YANKEE ATOMIC ELECTRIC COMPANY

Subject: Category "A" Item 2.1.9 - Reactor Coolant System Venting

SKETCH A (REV. 1)

YR-PROPOSED
 MAIN COOLANT
 VENT SYSTEM

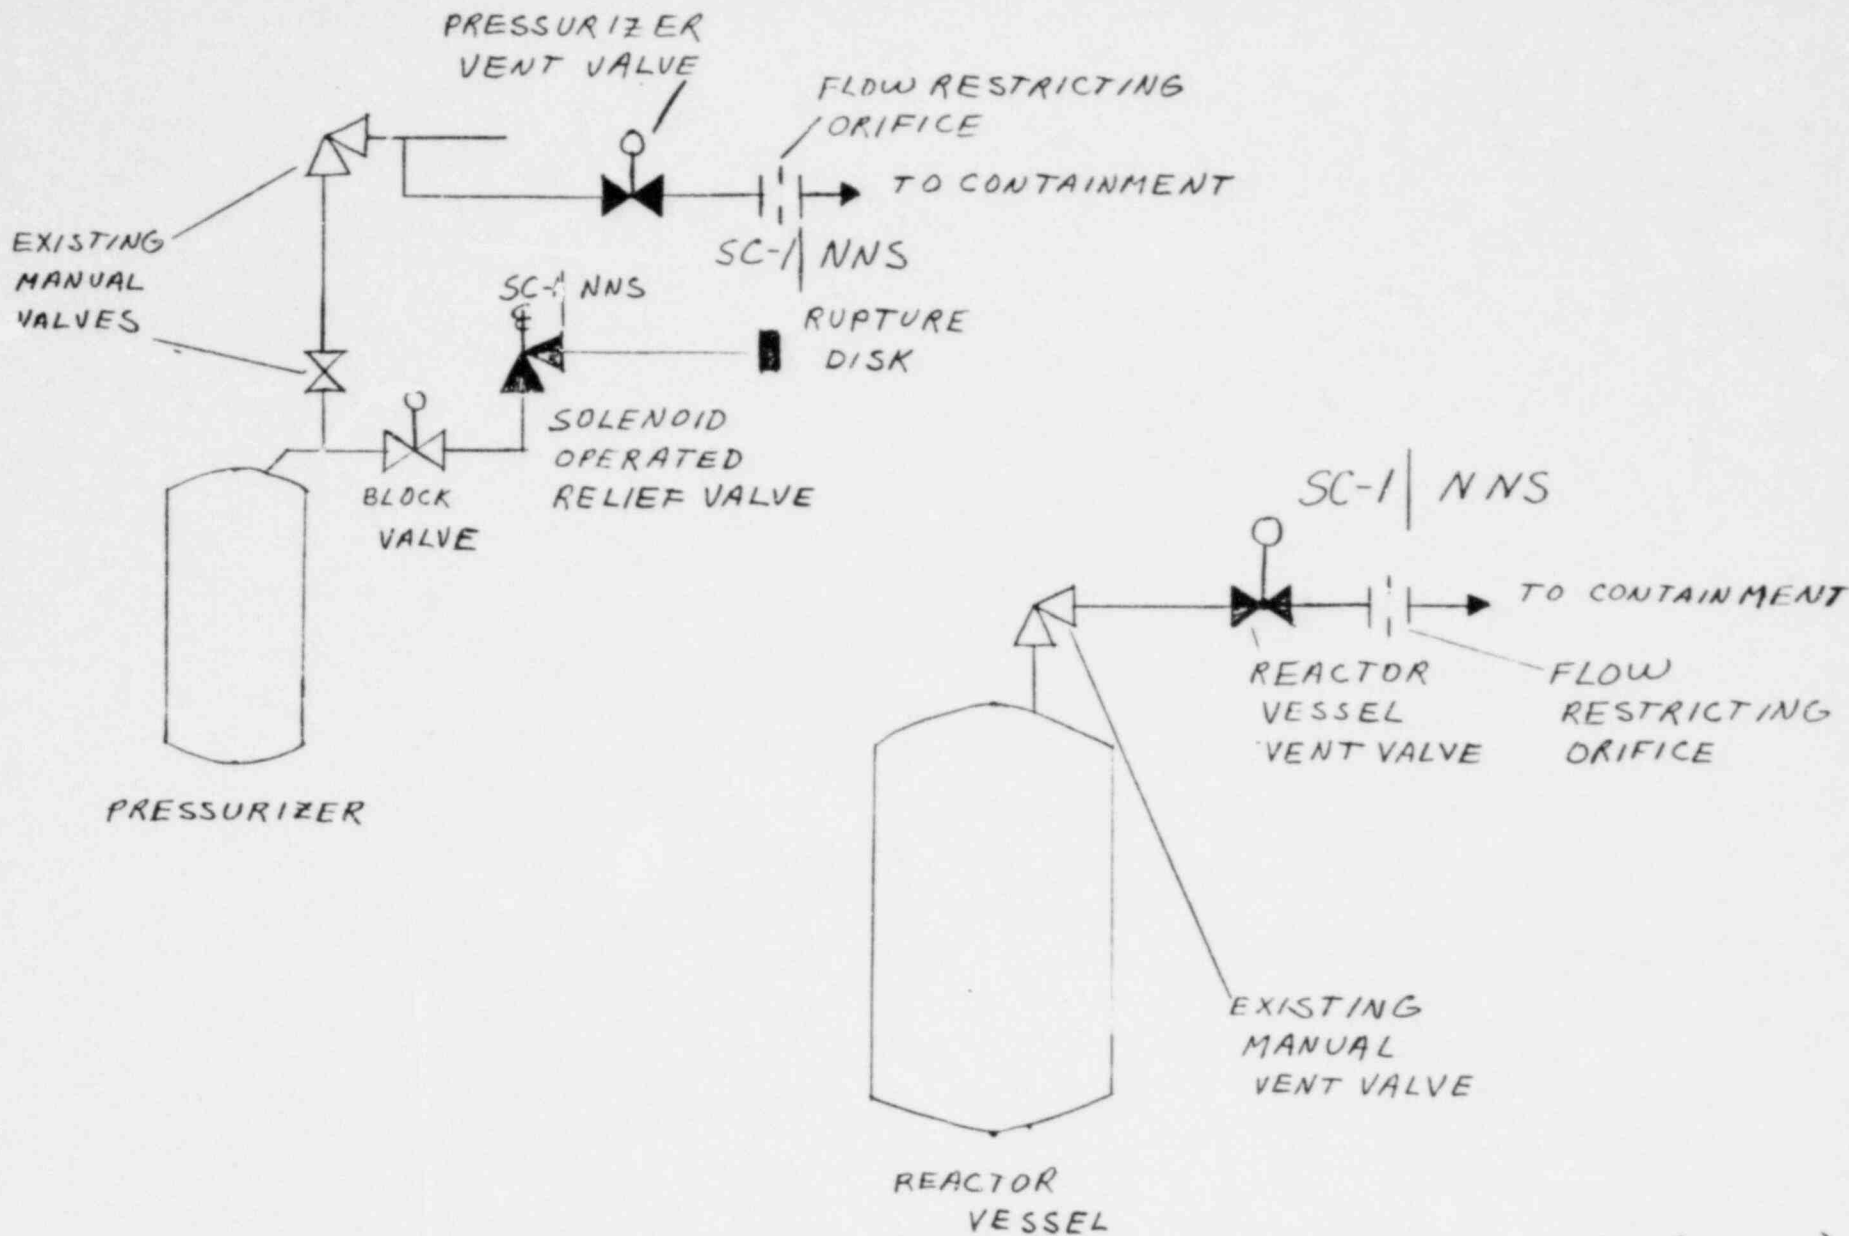
1. The vessel head vent will be piped directly to the containment atmosphere. This area is more suitable for reactor vessel venting purposes. Adequate ventilation is provided to insure mixing of the gases.
2. A motor operated valve with suitable restriction orifice will be installed in the pressurizer vent path, and vent directly to the containment atmosphere.

Sketch A shows the proposed vent path modifications for the reactor vessel head and pressurizer. The equipment will be installed by January 1, 1981. As indicated in Reference (c), a proposal review by the staff is required prior to installation. Since our effort to implement this modification will proceed in parallel, we request that your evaluation be performed in a timely fashion.

Sketch A, attached, provides a flow diagram of the proposed system. The reactor vessel head vent consists of a 1" motor operated valve, installed downstream of an existing manual vent valve. A flow restriction limits flow rates through the vent path to below the charging system makeup capability. The vessel head vent is piped directly to the containment atmosphere. Adequate ventilation is provided to provide sufficient mixing.

The pressurizer vent consists of a motor operated valve and suitable restriction orifice installed downstream of an existing manual valve. This design is similar to that used for the reactor vessel head vent.
